Standard Stair Section shown  
 (Crossover Stair Section top rail is 6" longer)

SHEET SIZE= C	DRAWN BY: wjm	PART NUMBER:
SCALE = none	DATE DRAWN: 12-16-2009	
STANDARD TOLERANCE: .00 ±.01 FRACTIONS: .000 ±.005 ±1/8"	FILE LOC: Z:\Aluminum\Westbury\C30 Riviera\C30 Riviera\Section\Stair	STYLE: Riviera
DRAFT: 20101025-4	FILE NAME: C30 8ft Stair Section	REV. D

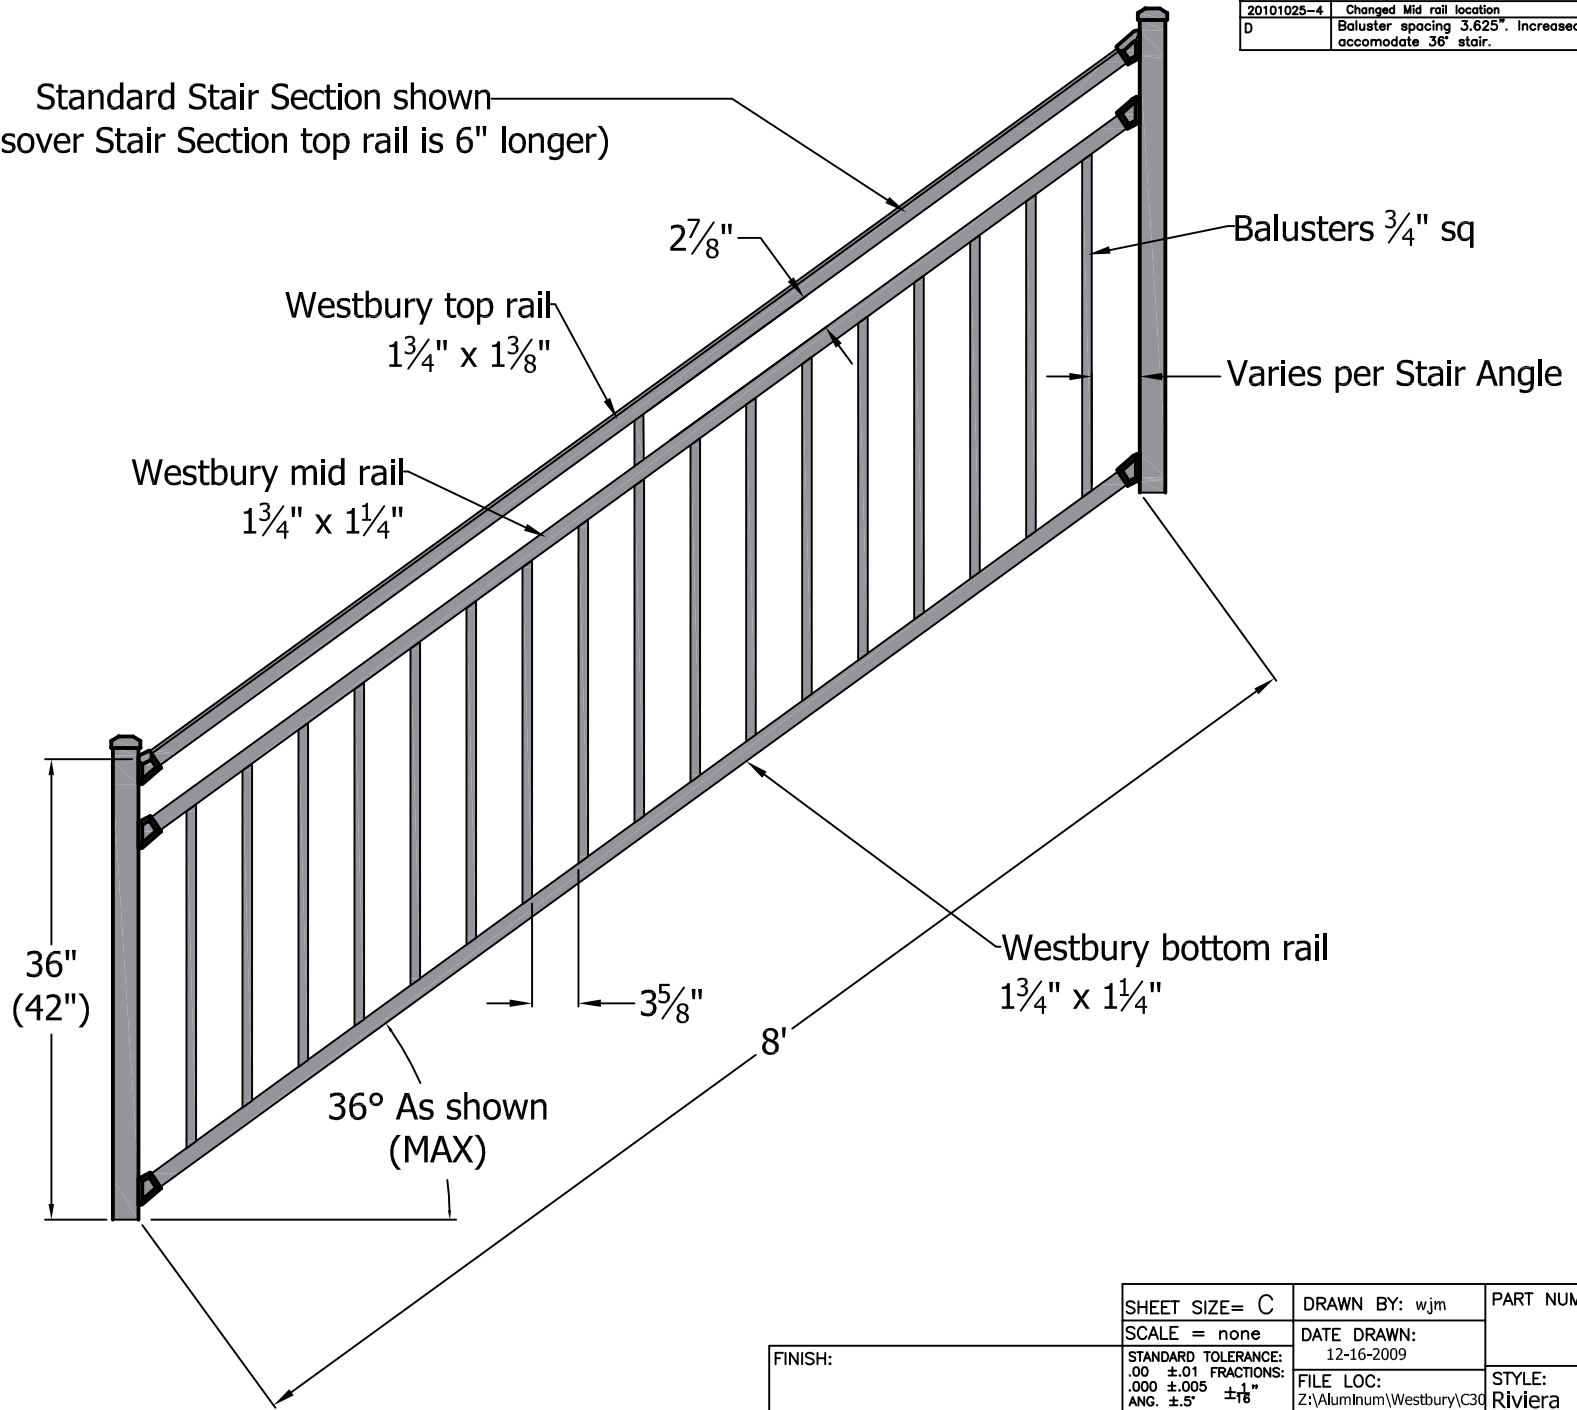
REV.	REVISION	DATE
20091223-2	Added center support	12-23-09
20100826-3	made 3 7/8" dim vertical ILO aligned	8-26-10
20101025-4	Changed Mid rail location	10-25-10
D	Baluster spacing 3.625". Increased hole size to accommodate 36" stair.	2/13/15
